Report on PolyMet Tailings Basin Geology and Proposed Engineering Controls

Paula Maccabee
Attorney for WaterLegacy
1961 Selby Avenue
St. Paul, MN 55104

J.D. Lehr
Professional Geologist
P.O. Box 217
Lutsen, MN 55612

Date: January 4, 2022

FIGURE 17. SURFICIAL GEOLOGY INDICATES INCREASED SEEPAGE ALONG NORTHERN PERIMETER OF FTB

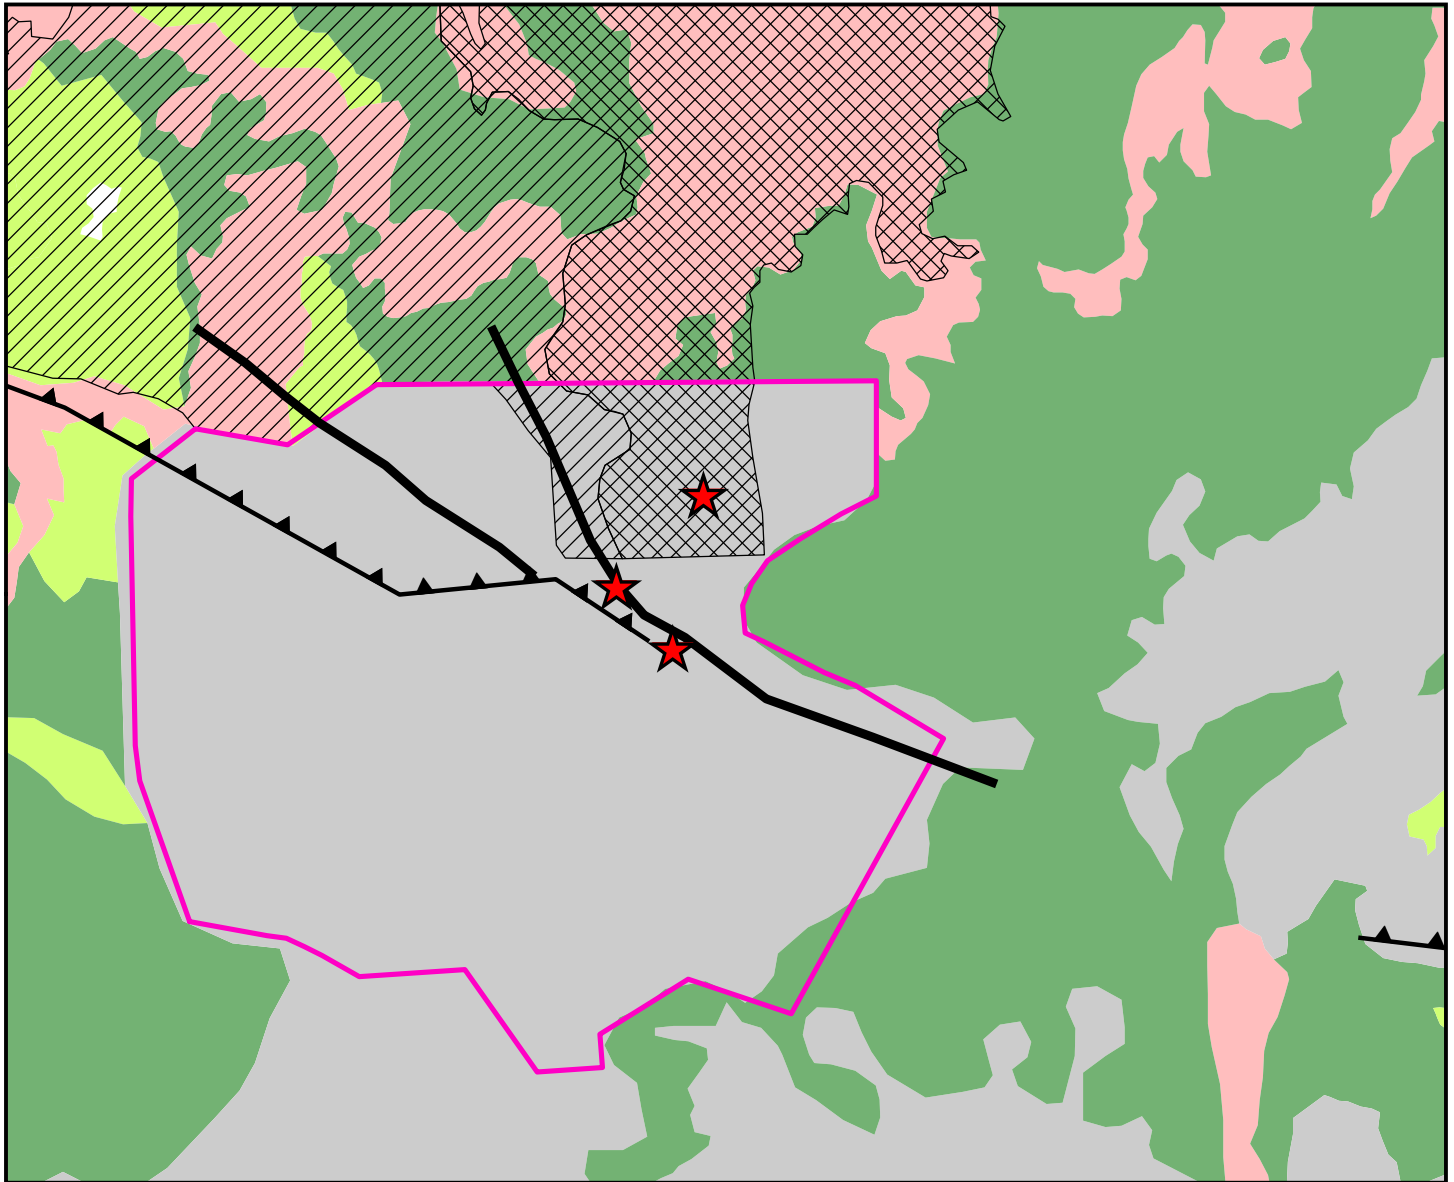
PolyMet’s assumptions regarding glacial sediments lead to overly optimistic predictions regarding efficacy of the seepage capture system. For modelling purposes, the sediment beneath the tailings basin was assumed everywhere to be glacial till. However, published surficial geologic maps show the FTB site to be underlain by a variety of glacial sediments. This well-documented heterogeneity is important because areas of glacial outwash sand and gravel can increase permeability and therefore transmit higher volumes of groundwater seepage.

The distribution of surficial glacial sediments surrounding and beneath the tailings basin according to published sources is shown on Figure 17. The background mapping is from the most recent Minnesota Geological Survey compilation of surficial geology. In addition, Figure 17 shows two relevant mapping units from the geologic map contained in my thesis. This mapping shows the area along most of the northern perimeter of the tailings basin to be underlain by extensive sand and gravel.

Four separate published (and peer-reviewed) geologic maps^{64, 65, 66, 67} document a glacial ice margin extending right through the FTB site during the waning stages of the ice ages (Figure 17). My thesis

FIGURE 18. ARTESIAN GROUNDWATER CONDITIONS MAY PRECLUDE PROPOSED SLURRY WALL

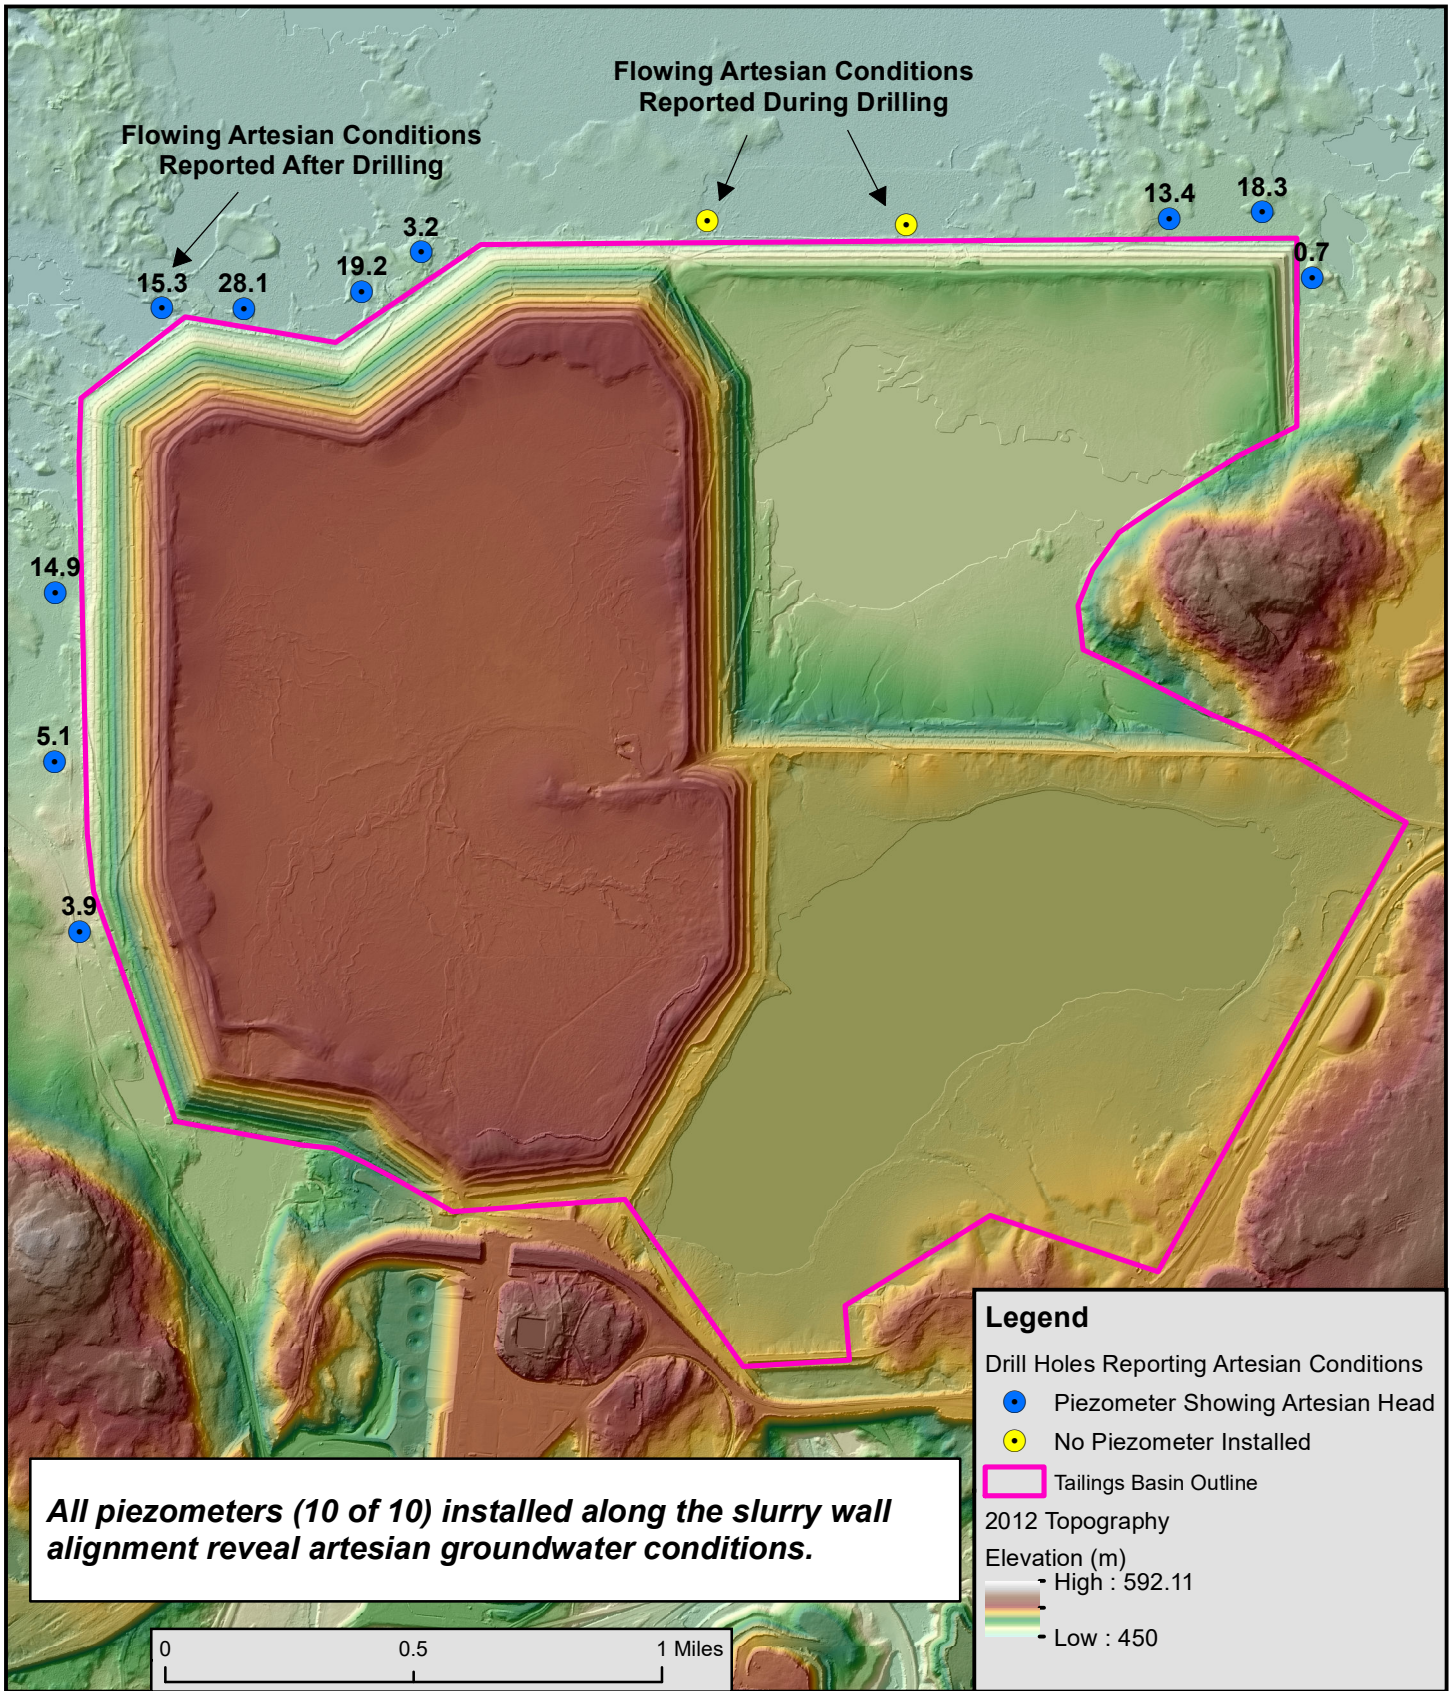
According to drilling records in the Geotechnical Report, artesian groundwater conditions are widespread along the alignment of the proposed seepage capture system. Every single piezometer⁶⁹ installed show artesian groundwater conditions to be present (Figure 18 and below).

collapse, or where a SBSW [soil-bentonite slurry wall] likely won't work" if a "layer anywhere in the excavated profile with artesian head conditions" or "highly organic soil-like peat"⁷⁹ exist. Widespread artesian groundwater conditions, groundwater levels "at or just below the ground surface,"⁸⁰ (Table 3 and Table 4) commonplace occurrence of boulders significantly larger than the width of the slurry wall and thick intervals of peat along the alignment of the proposed seepage capture system are not accounted for in PolyMet's plans to contain 100% of groundwater seepage.

FIGURE 19. CUMMULATIVE SUBSURFACE CONDITIONS DO NOT SUPPORT PROPOSED DESIGN

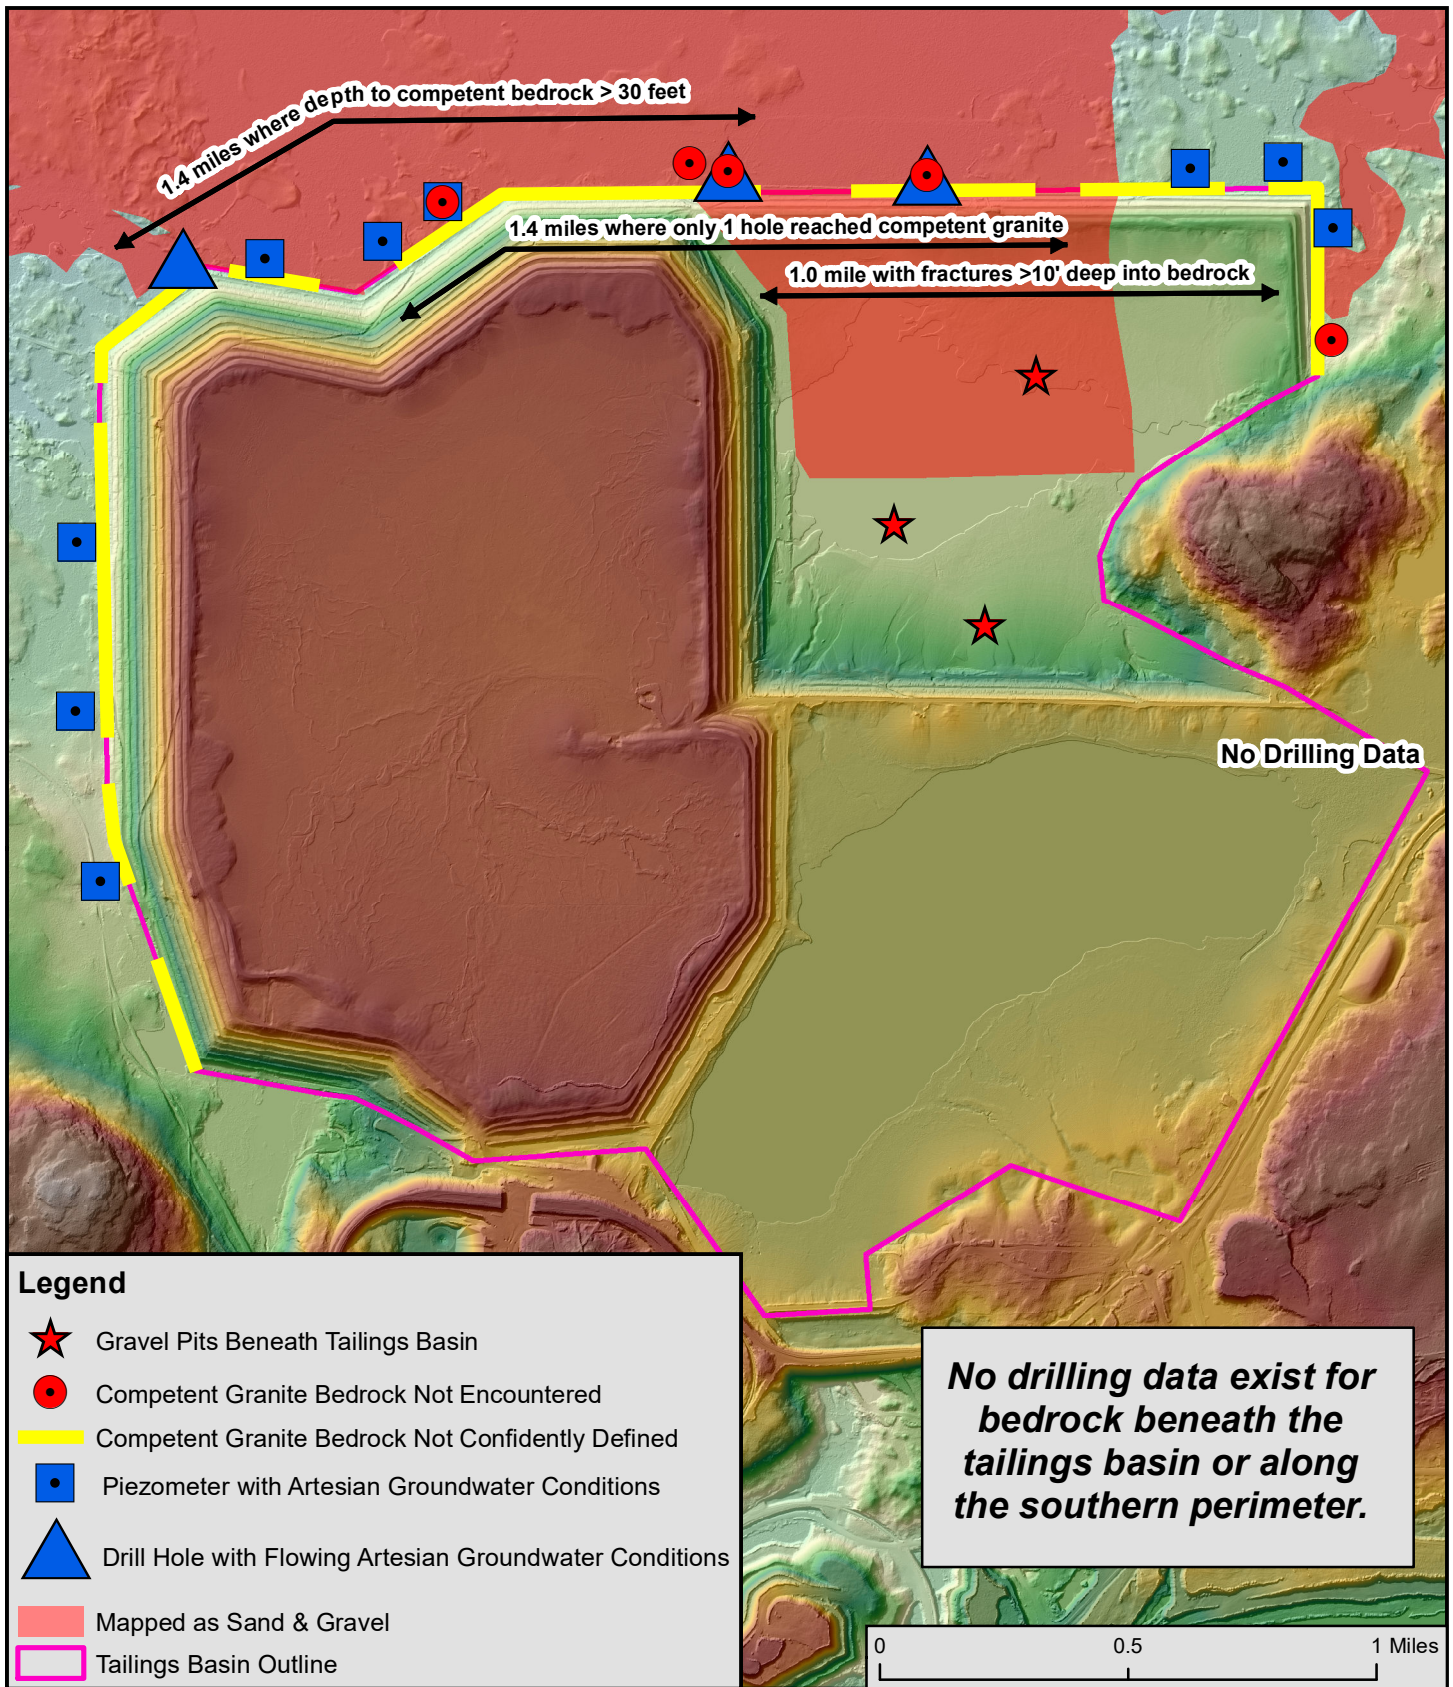
Figure 19 shows the alignment of areas with the most fractured bedrock (lowest RQD values), the greatest depths to reported competent bedrock, substantial amounts of sand and gravel, artesian groundwater conditions and high artesian heads (Figure 18) along the northern perimeter of the tailings basin. Coupled with the low degree of confidence where competent bedrock is located and the total lack of bedrock data from beneath the tailings basin and along critical segments elsewhere around the tailings basin perimeter, these adverse geological conditions will have synergistic negative effects on the feasibility of slurry wall construction and its performance, especially along the northern perimeter.

TABLE 10. PACKER TESTING INTERVALS AND RQD

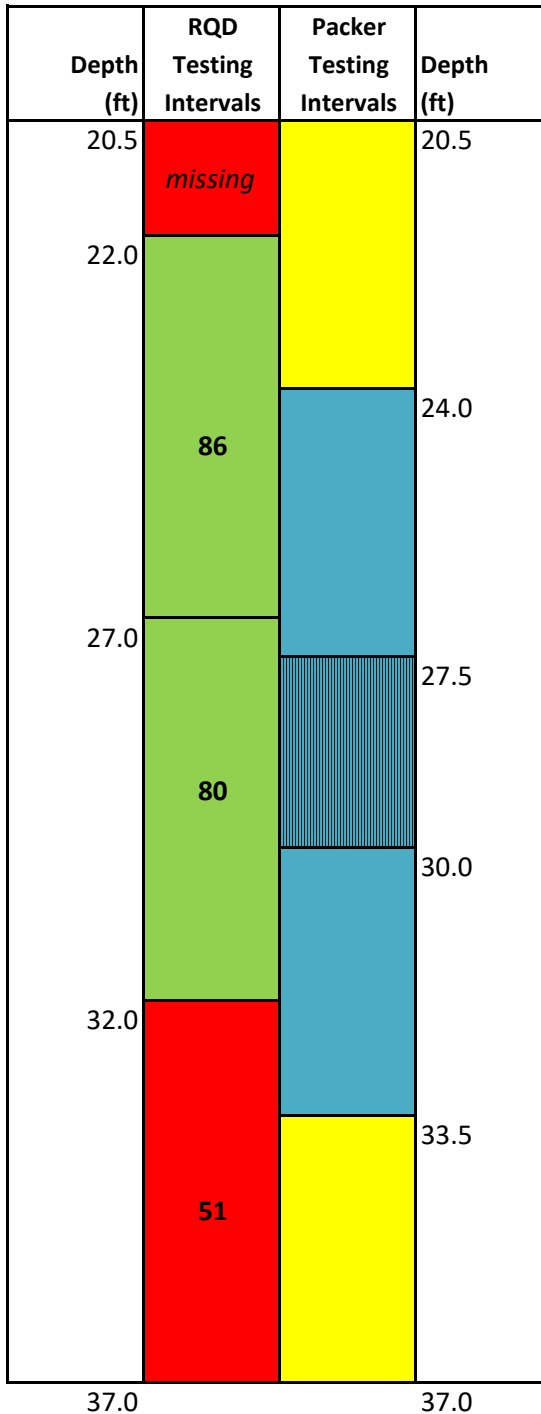
A more troubling pattern in exists for drill hole B14-65 (Table 10). In this hole, packer tests were avoided not only in the shallower bedrock where rock quality was low, but there was also a gap in packer testing between 33.5 and 37 feet, coincident with a drop in RQD. By excluding the interval 33.5 to 37 in this hole from packer testing Barr overlooked an opportunity to directly measure the hydraulic conductivity of its assumed “impermeable” zone. This type of sampling bias is shown for every interval selected for packer testing (Tables 7 through Table 11). The full range of groundwater conditions present in the bedrock can’t be addressed without looking at both ends the ends of the spectrum.
